Piper Aircraft Corporation  
Vero Beach, Florida, U.S.A.

# SERVICE No. 933A BULLETIN

Date February 20, 1990 S

SUBJECT: Trunnion Replacement

SKETCH "A"

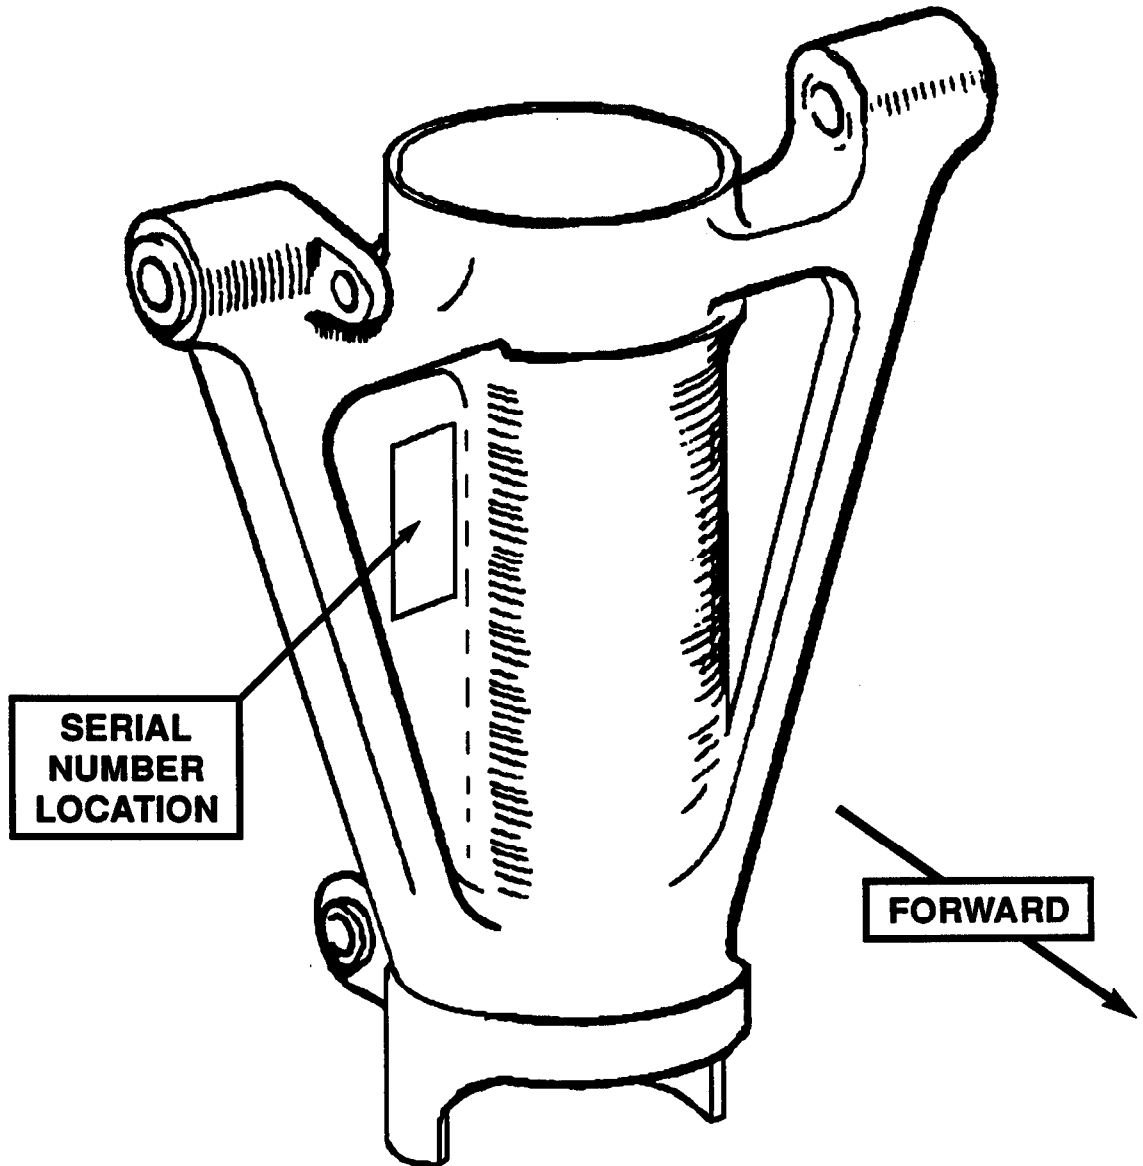
1. Locate serial number etched on the nose gear trunnion. (See Sketch "A") This is located on the front of the trunnion on the left web as you look aft.

2. If the serial number falls between 15200 through 15313, the trunnion must be removed from service. Replace with Nose Gear Trunnion, Piper Part Number 67054-003 with serial number not in the effected range.
3. If the nose gear trunnion requires replacement, place aircraft on jacks and refer to the appropriate Service Manual for instructions and procedures for removal and reinstallation.
4. Following the nose gear trunnion replacement, perform gear retraction cycle check per appropriate chapter of the Maintenance Manual. Upon successful completion, remove aircraft from jacks.
5. Make an appropriate logbook entry of compliance with this Service Bulletin.
